## **FIRMWARE RELEASE NOTE**

# Two-Wire IP Video Intercom

DS-KV8103-IME2  
Door Station

DS-KH8340-TCE2  
Indoor Station

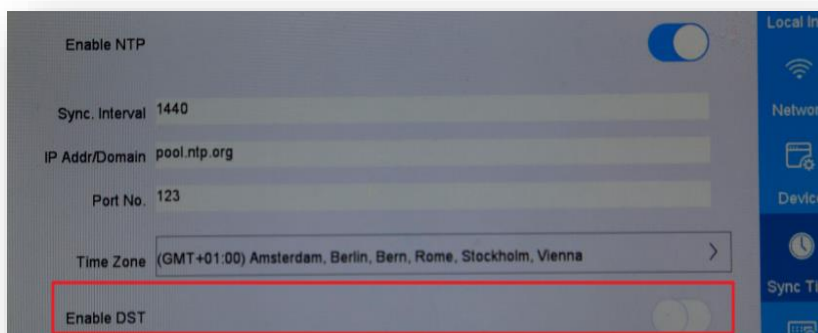
1. Added Hungarian and Romanian languages for GUI and voice prompts.
2. Captured photos and voice messages are linked directly with the missed call:

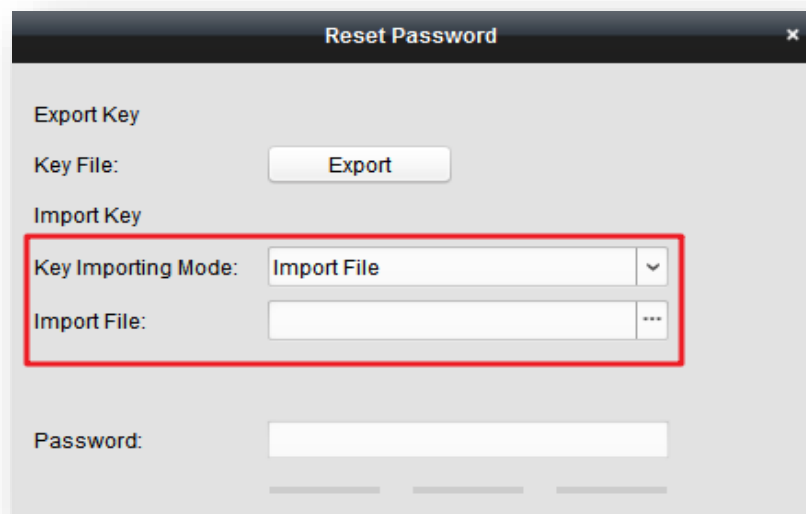
**4. Support of importing .XML file for resetting device activation password via SADP or iVMS-4200:**

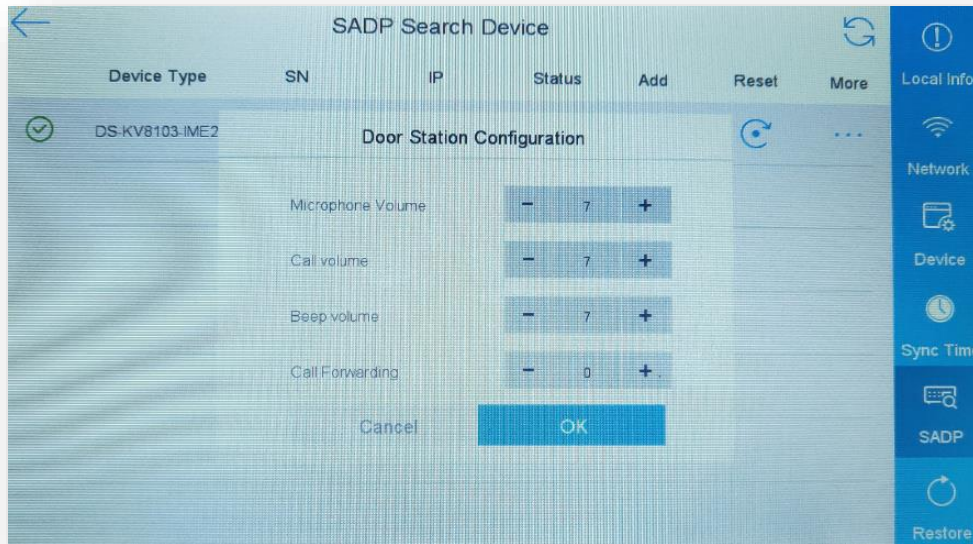
**5. Added additional door station settings in the SADP menu.**

In Settings->Configuration->SADP click the "More" button next to the door station to configure:

- Microphone volume
- Call Volume
- Beep (system sounds) volume
- Call forwarding delay to the Hik-Connect app

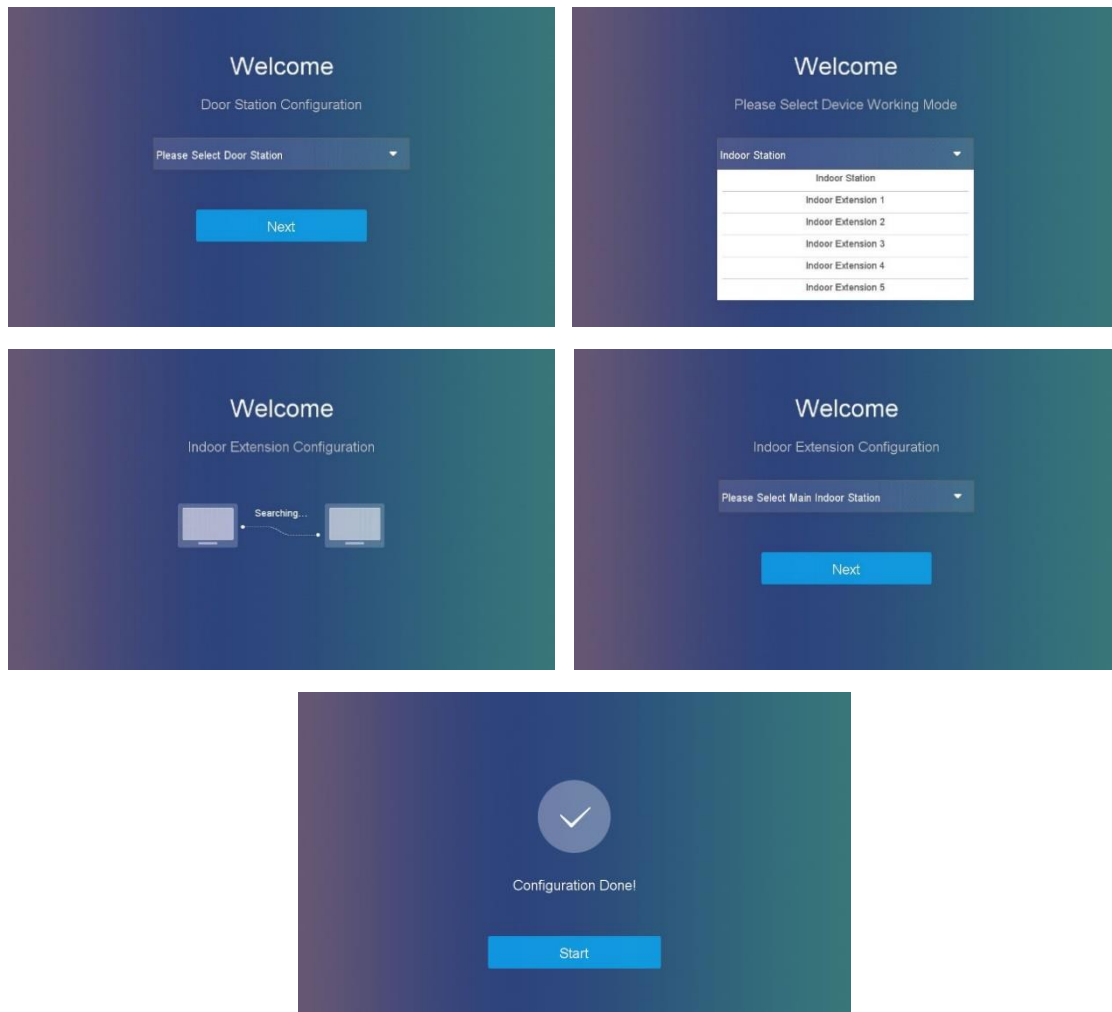
**3. Support Plug & play quick setup wizard**

If the device is powered out of the box or reset to factory defaults a simple configuration wizard will be displayed on the indoor station. Following the few steps will help user setup the system in no time without using any PC.

Connect door station to main indoor station

Connect indoor extension to main indoor station

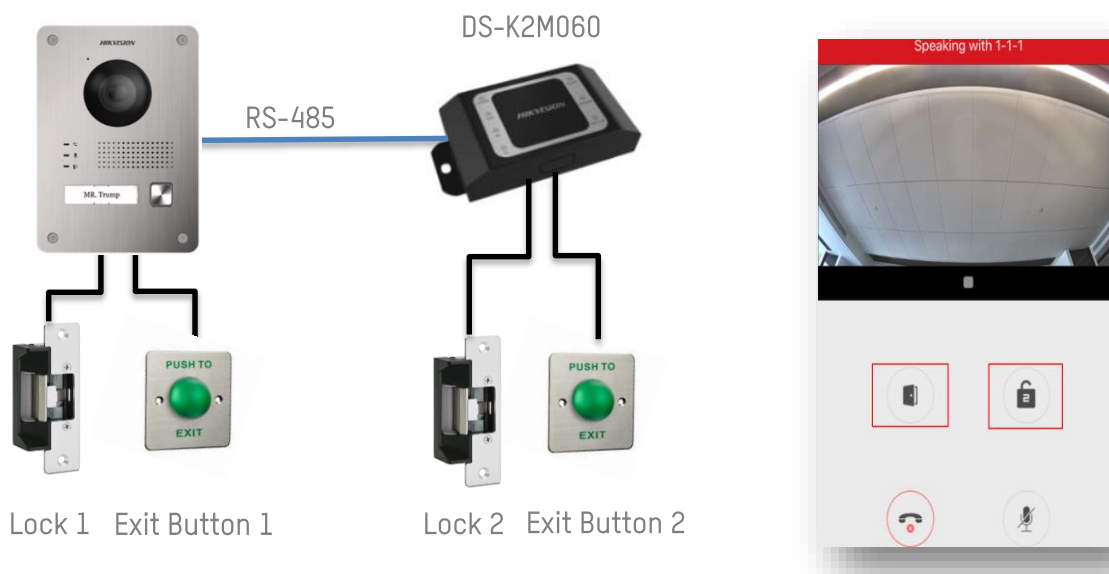
**5. Capture photos manually or on call button pressed.**

When a visitor press the call button a photo will be captured and stored in Information->Picture menu (SD card required, hot swap is not supported)). Photos can also be captured manually in a call.

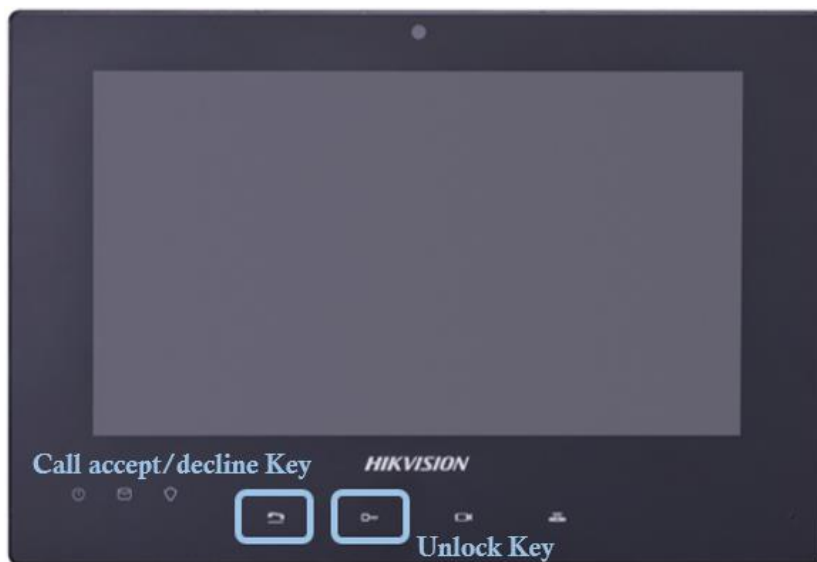
**8. Support pressing indoor station Call accept/decline key to answer/hang up directly and unlock key to open door directly**
